**Champlain Hudson Power Express**

**Case 10-T-0139**

**Segment 20B EM&CP**

**Justification for Centerline and Allowed  
Deviation Zone Excursions**

**Figure A HAR #1 Lower Hudson Reach SCFWH**

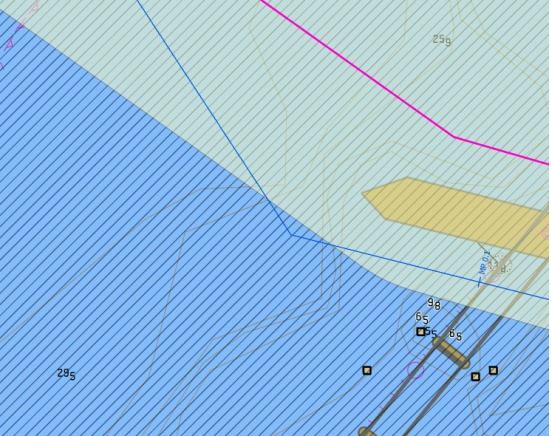
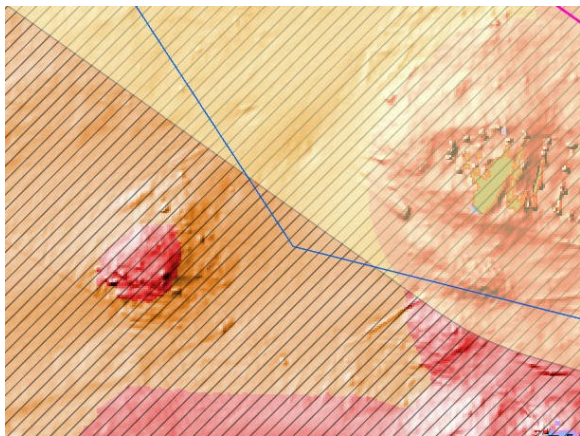
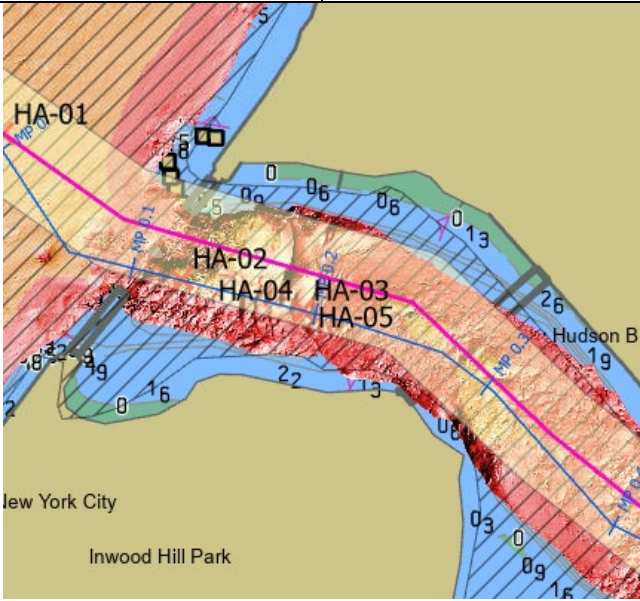
Near the northern terminus of the Segment, the cable route traverses through one SCFWH, the Lower Hudson Reach. Installation through this SCFWH cannot be avoided and was approved under the Certificated Route—however, because this relocation within the previously approved SCFWH is greater than 150 feet, CHPE is requesting approval of this deviation out of an abundance of caution.

The proposed route is moved to the south of the Certificated route, south of the Spuyten-Duyvil center bridge pier/abutment. The riverbed on the north side of the center bridge pier is uneven, presenting challenges to installation. On the south side of the center bridge pier, survey data shows smooth bathymetry, which allows the cable to be installed in a stable area where relatively high currents are present. The smooth riverbed is preferred from an engineering and installation feasibility standpoint.

The installation vessel requires ample space relative to the Spuyten-Duyvil Bridge pier to make the turn to the east, resulting in a deviation from the Certificated Route >150 feet.

This deviation is justified by engineering reasons (avoidance of uneven river bottom).
